## **IOWA DEPARTMENT OF TRANSPORTATION**

- **OFFICE:** Design
- **SUBJECT:** Field Exam

A field exam was held on Thursday, May 31, 2012, to review the proposed plan for reconstructing the westbound lanes of Interstate 280 from 0.8 miles south of U.S. 6 south to the Mississippi River, a distance of approximately 7 miles.

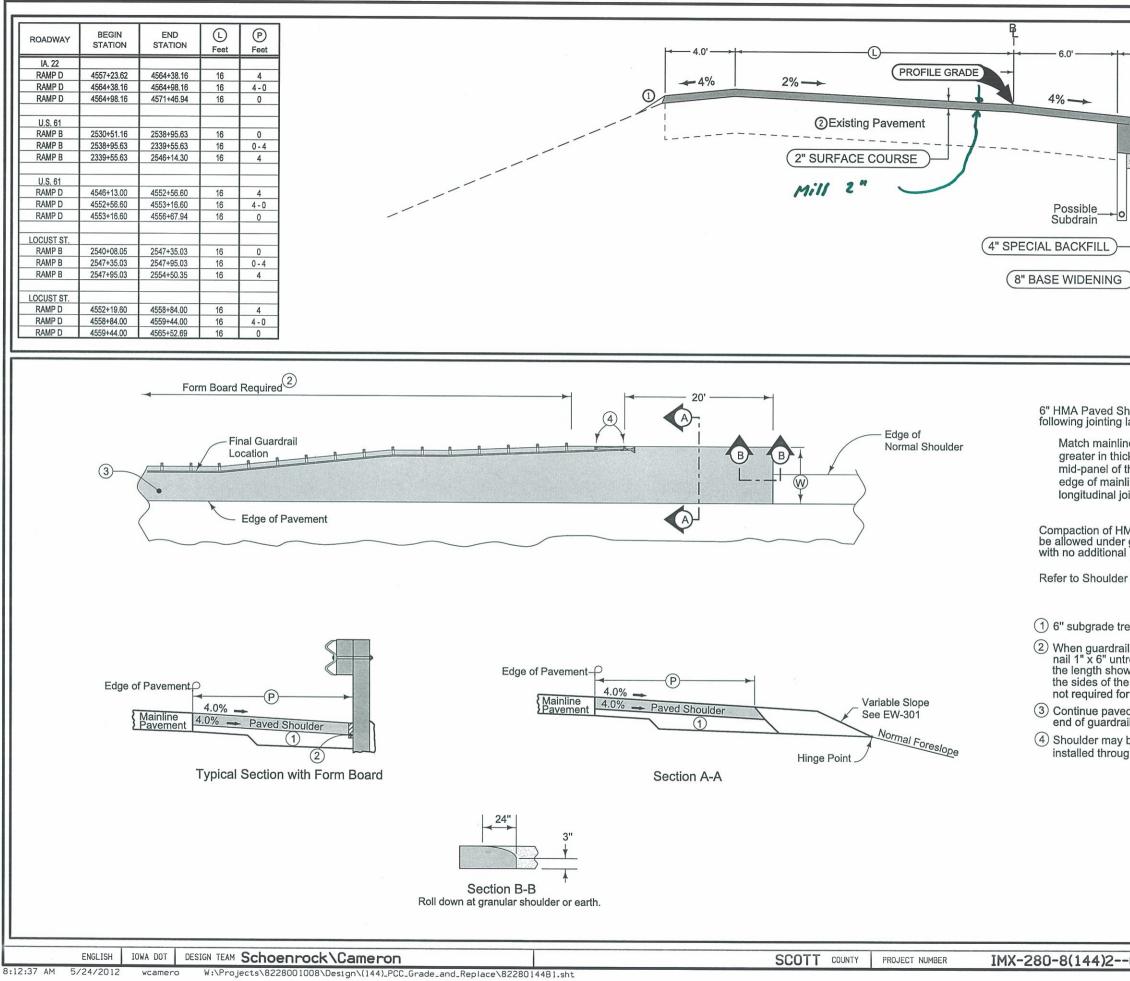
Tom (FHWA) to review shoulder width. Based upon truck DDHV 7 250 vpd. AASHTO recommends a 12' wide shoulder width be considered. Existing Foreslope shoulder is Received e-mail **Paved Shoulder Alternates** from Tom Parkon 6/22/12 stating Etter 10 ft shoulders are P END STATION Feet acceptable. 118+85 54 8 8 121+79.98 153+81.93 8 172+40.07 8 225+70.55 8 246+23.67 8 257+66.34 8 See Tab 100-24 for pavement quantities. 334+11 34 8 366+53.30 8 See Tab 112-9 for shoulder quantities. 417+40.00 8 470+80.66 8 514+00.00 8 WB I-280 P.C.C. INLAY SHEET NUMBER **B.1**
